South Texas Project Electric Generating Station 4000 Avenue F – Suite A Bay City, Texas 77414

January 21, 2009
U7-C-STP-NRC-090004

South Texas Project
Units 3 and 4
Docket Nos. 52-012 and 52-013
Second Re-submittal of Response to Request for Additional Information

South Texas Project
Units 3 and 4
Docket Nos. 52-012 and 52-013
Response to Requests for Additional Information

Figure 2.4-1 Landscape Features and Habitat Types of the STP (Source: Reference 2.4-2a)

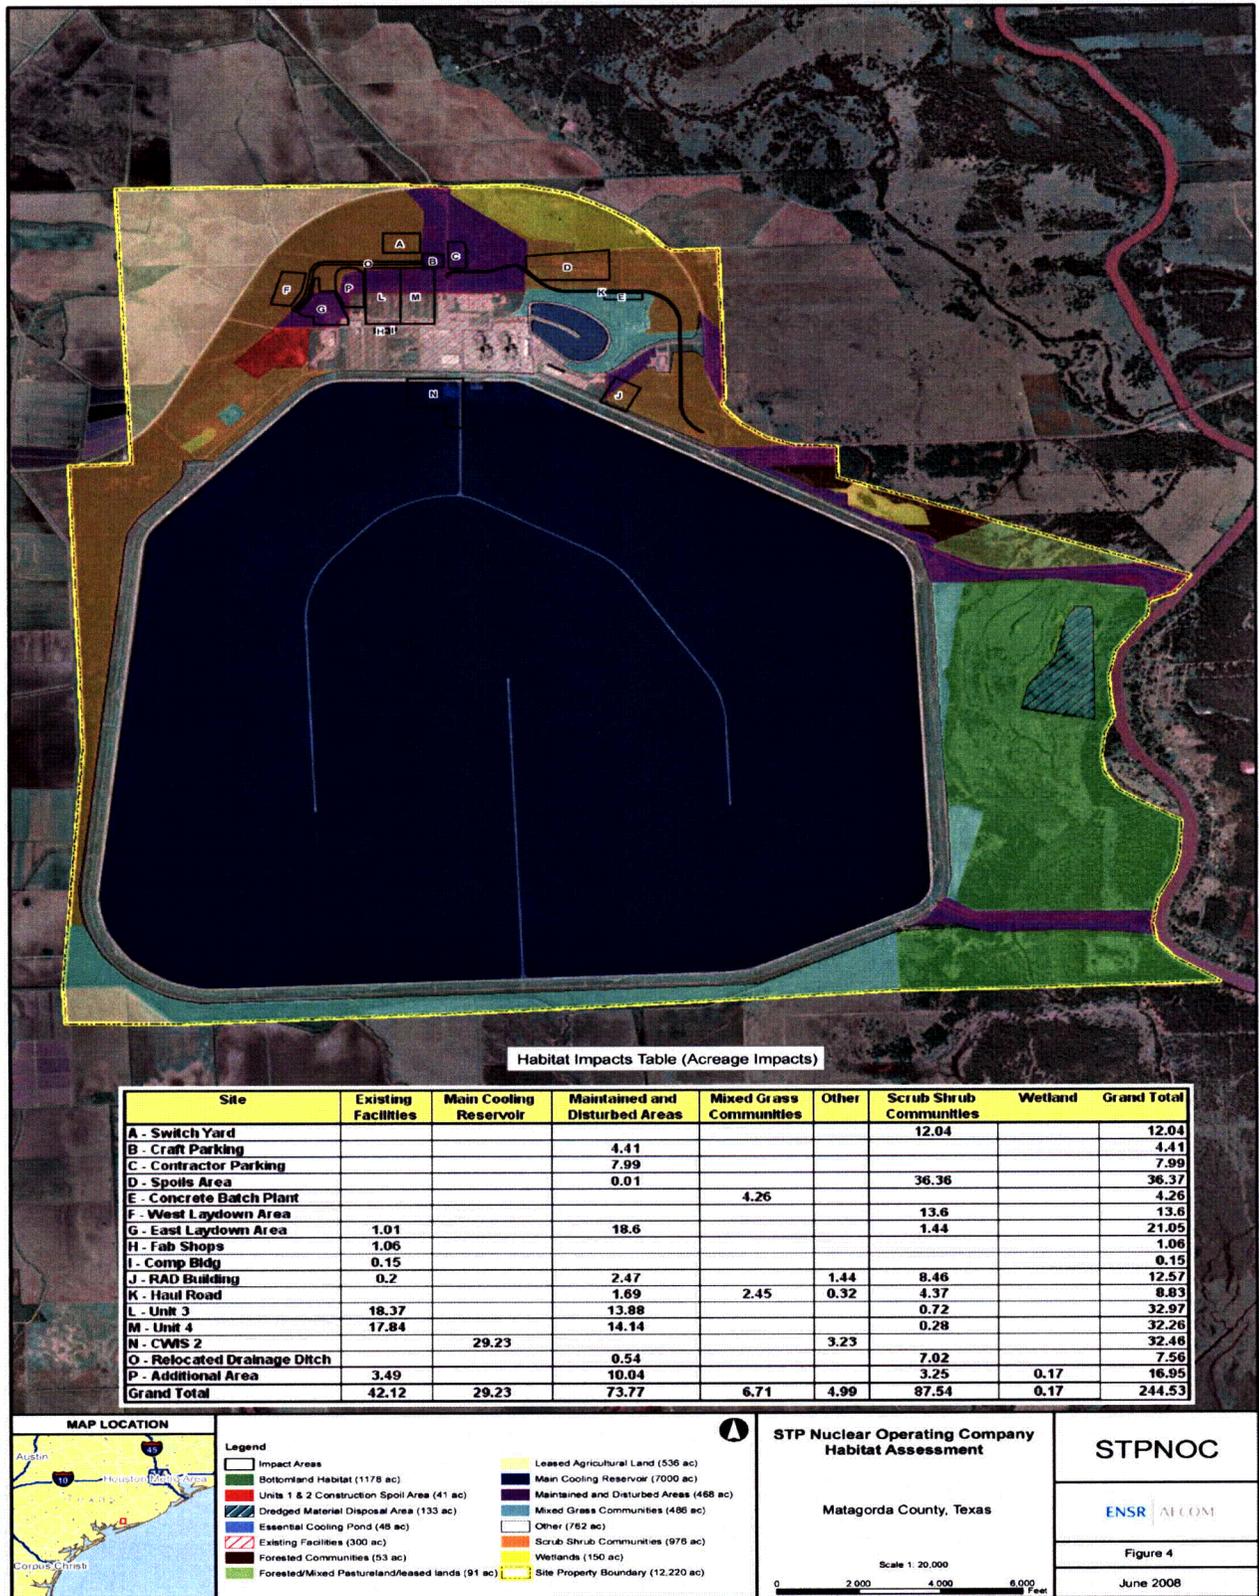
Provide a description of the dominant and common vegetation and wildlife species found in the habitats existing on the STP site, either as shown in Figure 2.4-1 of the ER, or as described and displayed at the site audit in draft documentation for habitat mapping conducted by ENSR for the applicant. Include information on large and small mammals (including bat species potentially present), common reptiles and amphibians found in the habitats on the STP site and the section of the Hillje transmission corridor to be upgraded. Some of this information is contained in the May 2007, ENSR Corporation Report: 10720-008, but habitat descriptions are not consistent between the ER and the ENSR 2007 report. During the site audit, contractor and applicant staff indicated that a new report describing the habitats on site and the wildlife commonly found in those habitats was under preparation. Provide the finished report.

Based on these reports, portions text of the ER will be revised as described below.

3 additional tables will be added and one figure (2.4-1) will be modified

A recent assessment of habitats/land uses within the 12,220-acre STP site reported 14 different habitats (Figure 2.4-1; Reference 2.4-2a). Two of these are open water habitats that occupy a majority of the STP site. The dominant feature of the site is the approximately 7,000-acre main cooling reservoir (Figure 2.4-1) that was established on the property by the construction of tall earthen embankments. The reservoir side of this embankment was lined with "soil-cement" to prevent erosion. Approximately seven miles of interior dikes were placed within the MCR (Figure 2.4-1) to enhance circuitous water flow, maximizing cooling. The Essential Cooling Pond is an approximate 46-acre impoundment immediately to the east of STP 1 & 2, and also is surrounded by an earthen embankment that is covered with reinforced concrete and/or soil cement for erosion protection (Reference 2.4-2b). The external side of the embankment of both reservoirs (approximately 760 additional acres) was planted with grass and is regularly maintained by mowing.
